CHAPEL HILL ADDITION
TO WICHITA, SEDGWICK COUNTY, KANSAS

RE: S/D 9884 - Final Plat of CHAPEL HILL ADDITION

STAFF REPORT

CASE NUMBER: S/D 98-84 - CHAPEL HILL ADDITION

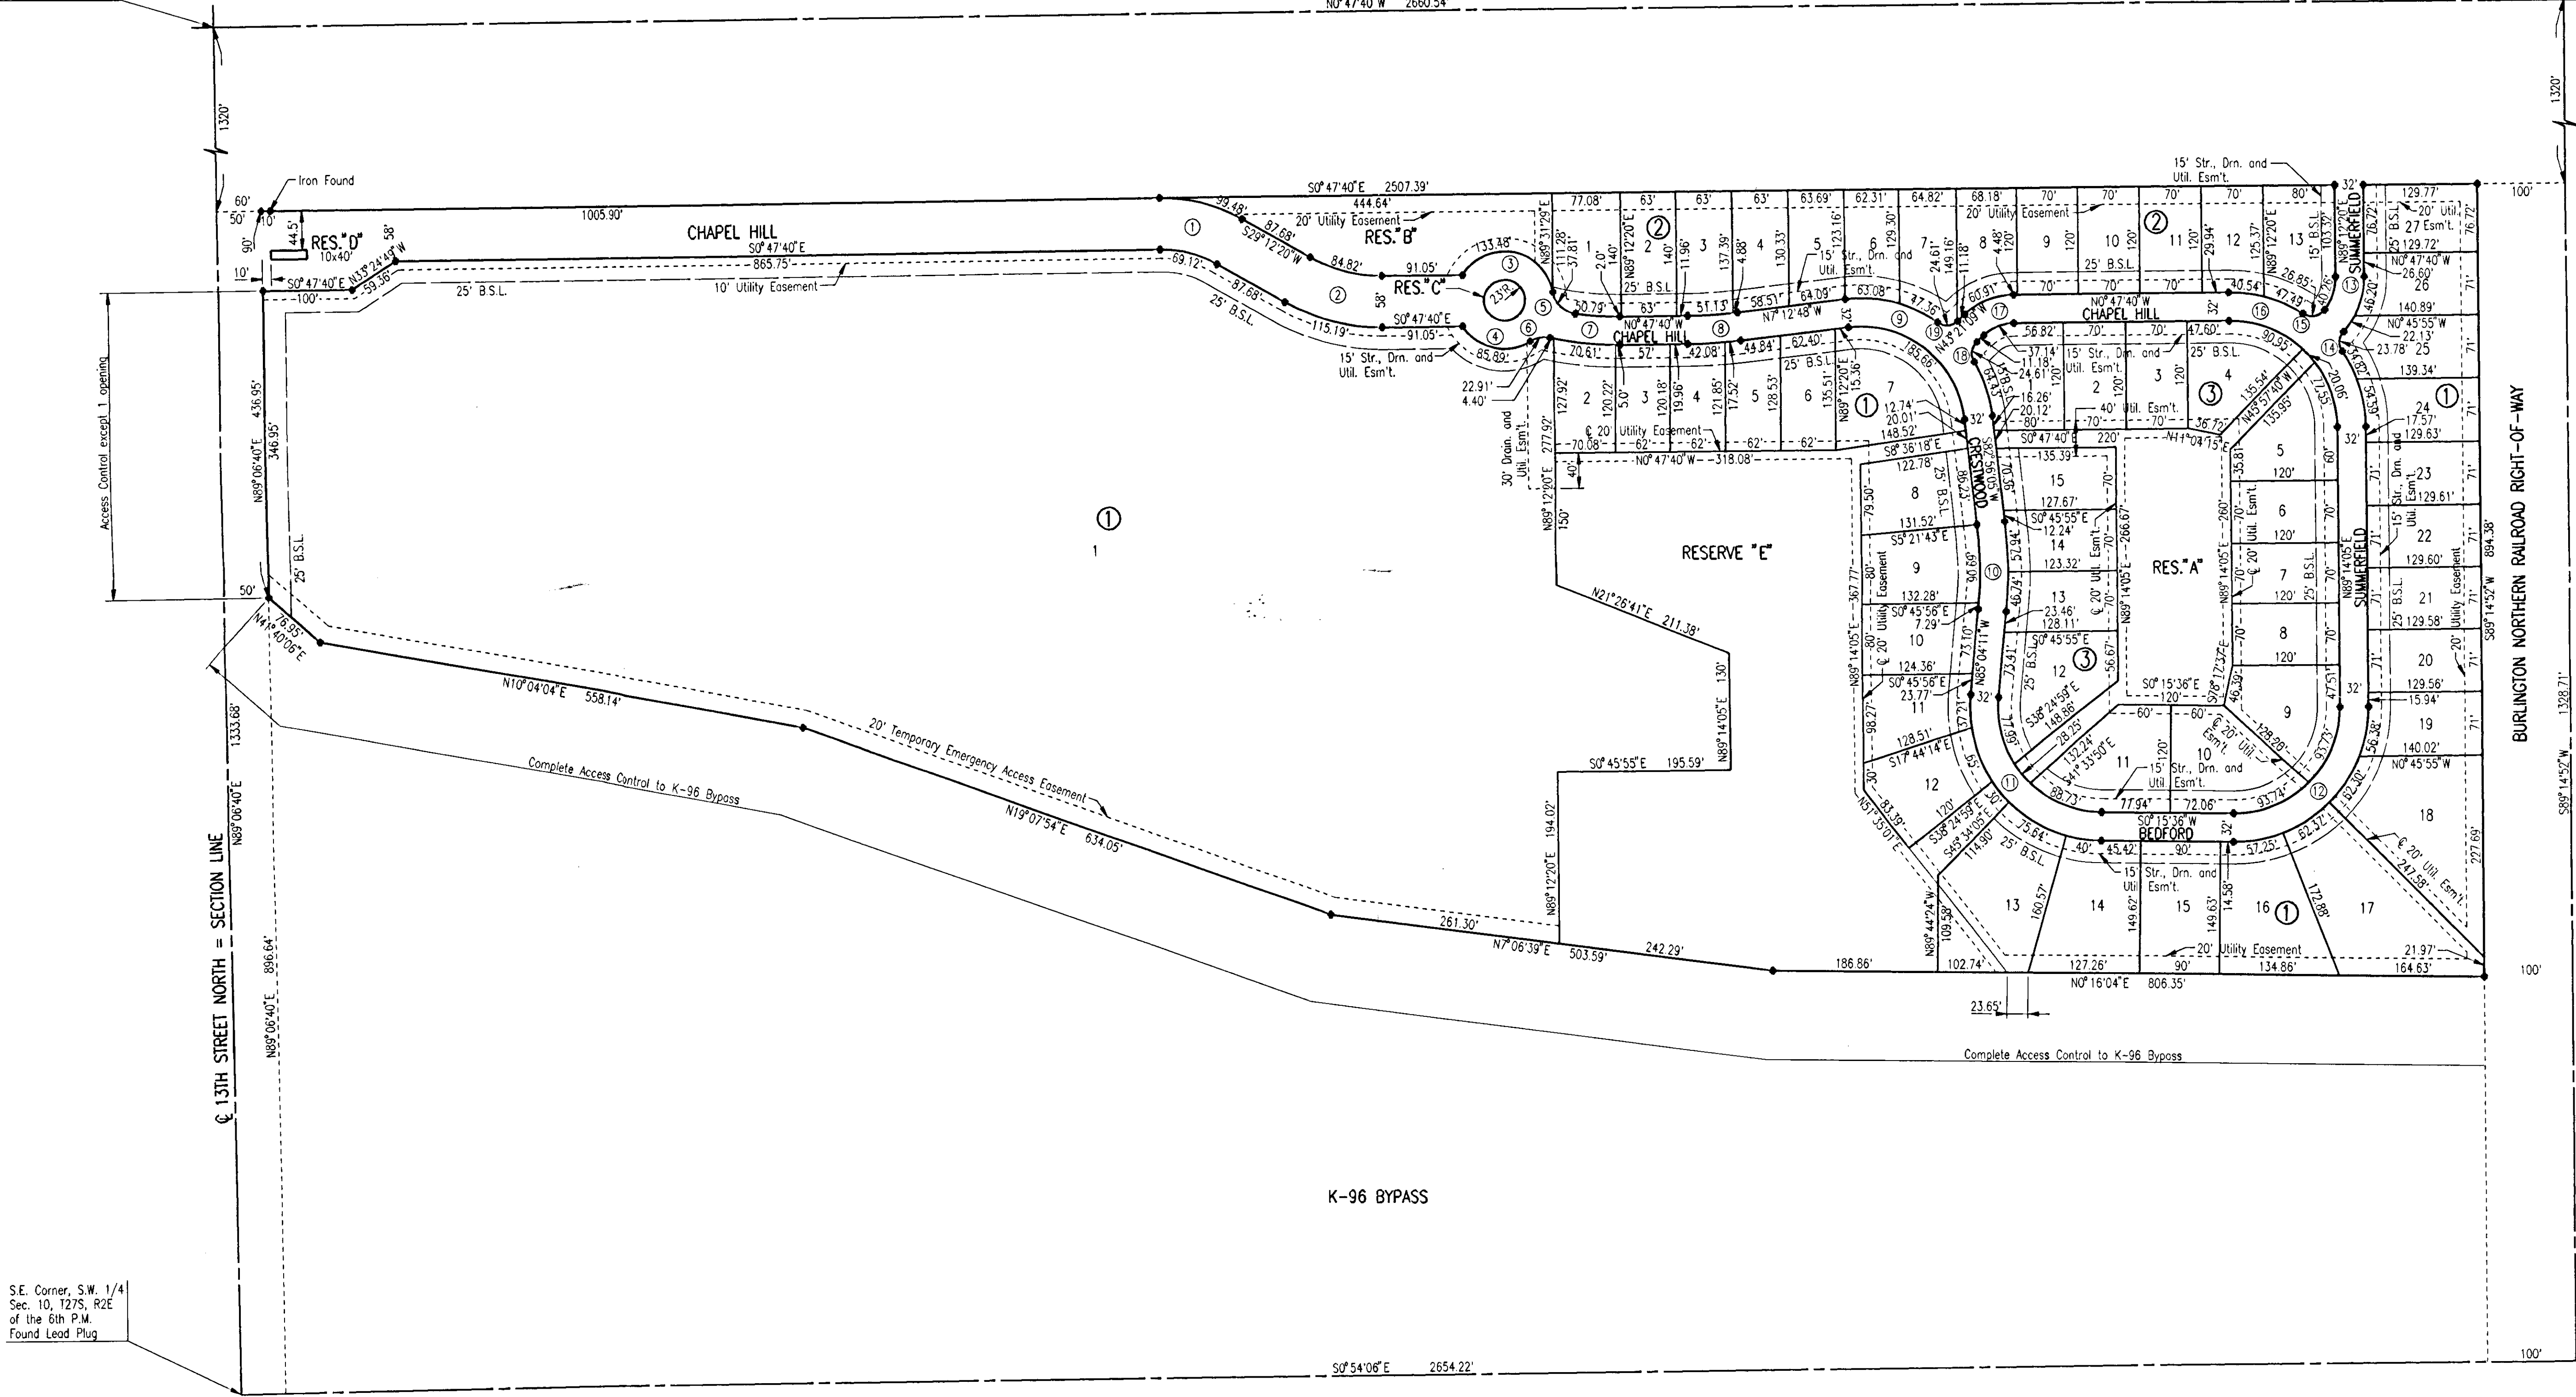
- E. **City Engineering** needs to comment on the status of the applicant's drainage concept and of any minimum building pad requirements as a result of a lake (Reserve E) being created. **A letter is needed from KDOT pertaining to their acceptance of drainage onto K-96. The drainage concept is approved. Minimum pad elevations need to be denoted for lots adjacent to the detention pond.**

- F. The plat denotes one access opening along 13th St. North. Traffic Engineering needs to comment on the need for complete access control on the east side of the frontage adjoining K-96. The plat's text on the final plat, shall note that access controls are being dedicated to the City of Wichita and that the location of the opening is subject to approval by the City Engineer. Access controls are sufficient.
- G. The distance to the northernmost lots is approximately 3,000 feet; in excess of the 600 foot maximum noted in the Subdivision Regulations for cul-de-sac access. Currently, the proposed street stub to the west does not have any connection and Fire Department needs to comment on a potential emergency access easement for a second point of access to this plat. City Fire Department requires a second point of access. Applicant has agreed to include an emergency access easement.

The final plat has included the requested emergency access easement; however it should be extended northward to connect with Crestwood Street.

- I. Since this plat proposes the platting of narrow street right-of-way with adjacent "15-foot street drainage and utility easements", a restrictive covenant shall be submitted which calls out restrictions for lot-owner use of these easements. Retaining walls and change of grade shall be prohibited within these easements as well as fences, earth berms and mass plantings.

- K. Traffic Engineering needs to comment on the need for improvements to 13th St. North. No improvements are needed.
- L. The applicant shall guarantee the paving of the proposed interior streets. For the narrow public 32-foot streets, this guarantee shall be for the 29-foot paving standard. This guarantee shall also provide for sidewalks along one side of the streets. The Applicant has submitted an alternate sidewalk plan. The plan denotes a sidewalk around the perimeter of the park (Reserve A) with connections along

- G. The distance to the northernmost lots is approximately 3,000 feet; in excess of the 600 foot maximum noted in the Subdivision Regulations for cul-de-sac access. Currently, the proposed street stub to the west does not have any connection and **Fire Department** needs to comment on a potential emergency access easement for a second point of access to this plat. **City Fire Department requires a second point of access. Applicant has agreed to include an emergency access easement.**

The final plat has included the requested minimum building pad elevations. City Engineering needs to comment on the status of the applicant's drainage plan. The drainage plan is approved. A drainage guarantee is required.

The final plat has included the requested emergency access easement; however it should be extended northward to connect with Crestwood Street.
